SERVICE BULLETIN

CHECKING OR REPLACEMENT OF THE PROPELLER GEARBOX FOR ALL VERSIONS OF THE ROTAX[®] ENGINE TYPE 912 AND 914

SB-912-027

SB-914-010

Bild / fig. 1

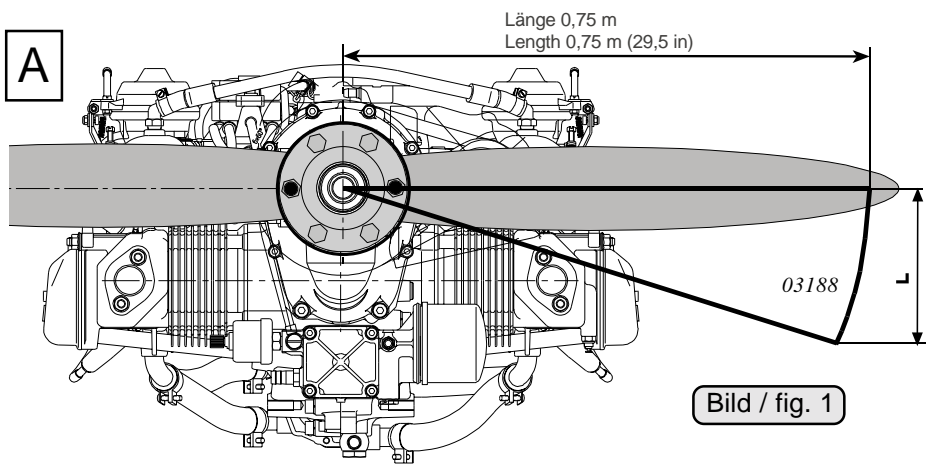
|| - The distance or angle of propeller blade moving along the complete backlash can be checked with a suitable device as follows:

Measured at a radius of 0,75 m (29,5 in) the backlash is on:

- doghub of **15° backlash: L less than 315 mm (12.4 in)**

- doghub of **30° backlash: L more than 315 mm (12,4 in)**

|| **ATTENTION:** The reason for a backlash of more than 315 mm (12,4 in) could be an unsuitable combination of doghub and doggear. Replace the gearbox according to instructions.

|| If the measured backlash is less than 315 mm, the gearbox is unaffected and no further measures are necessary.

Bild / fig. 10

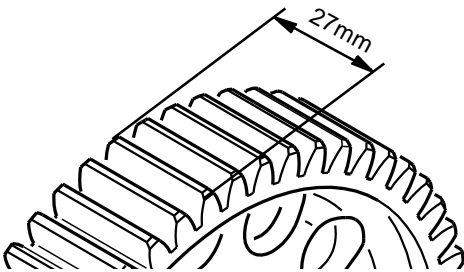
Slide drive gear (19) onto crankshaft (20). Fit hex. nut (21) M30x1,5 secured with LOCTITE 221 and friction washer (22) VS 30 on crankshaft. Torque to 200 Nm (1770 in).

■ ATTENTION: Dog gear and drive gear are paired and are marked with a consecutive serial number (23). Use only parts of the same serial number!

Bild / fig. 11 04111

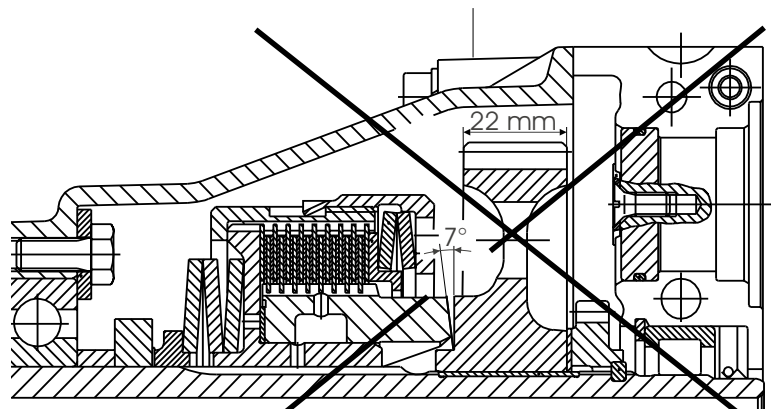
|| An unsuitable combination of a 7° tapered doghub and a 30° backlash doggear may have been installed in the gearbox of the engines affected.

- ||| ◆ NOTE: This new parts requirement is only required if a doghub of 7° tapered surface in combination with a doggear of rectangular support face have been installed (see article 3.2).

◆ NOTE: The repaired or replaced gearbox is also with a backlash of 30°, but is equipped with a dog hub of rectangular surface (see fig.11).

■ ATTENTION: dog hub with 7° tapered surface (use only for gear set with dog gear of 27 mm width)

■ ATTENTION: dog hub rectangular surface (use only for gear set with dog gear of 22 mm width)

FALSCH KOMBINATION /
WRONG COMBINATION
